Edwin I. Hatch Nuclear Plant – Unit 2  
Response to Request for Information Regarding Proposed Inservice Inspection  
Alternative HNP-ISI-ALT-HDPE-01, Version 2.0

**Edwin I. Hatch Nuclear Plant – Unit 2  
Response to Request for Information Regarding Proposed Inservice  
Inspection Alternative HNP-ISI-ATL-HDPE-01, Version 2.0**

**Enclosure 2**

**Revised Pages E2-28 and E2-31 of Alternative Technical Requirements**

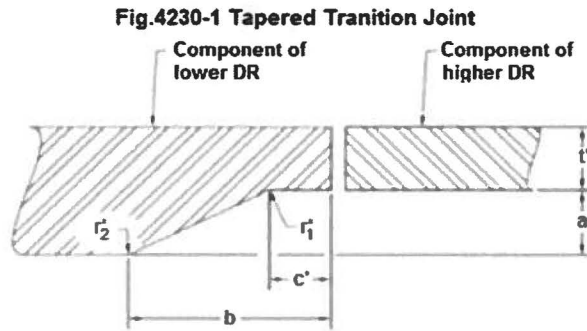
Paragraph 4231(c) states for items with different DRs, the item with the smaller DR will be counter bored and tapered to equal the wall thickness, or its outside diameter will be machined and tapered to equal the wall thickness of the item with the larger DR. Please specify NDE techniques and measurements that will be incorporated to assure the required DRs are met and that machined surface is free of indication and possible porosity.

4231(c) has been revised in part to read (without the underline): "...with Fig. 4230-1 (a) or (b). Machined surfaces will be visually examined to verify absence of porosity or other deleterious surface conditions, and required wall thicknesses will be verified by direct measurement." Direct measurement will typically be by

tape or rule, but may also be by calibrated ultrasonic thickness measurement. Enclosure 2 of this letter contains the revised page E2-28 of the ATR.

(c) For items with different DRs, the item with the smaller DR will be counterbored and tapered to equal the wall thickness, or its outside diameter will be machined and tapered to equal the wall thickness of the item with the larger DR and will comply with Fig. 4230-1 (a) or (b). Machined surfaces will be visually examined to verify absence of porosity or other deleterious surface conditions, and required wall thickness will be verified by direct measurement.
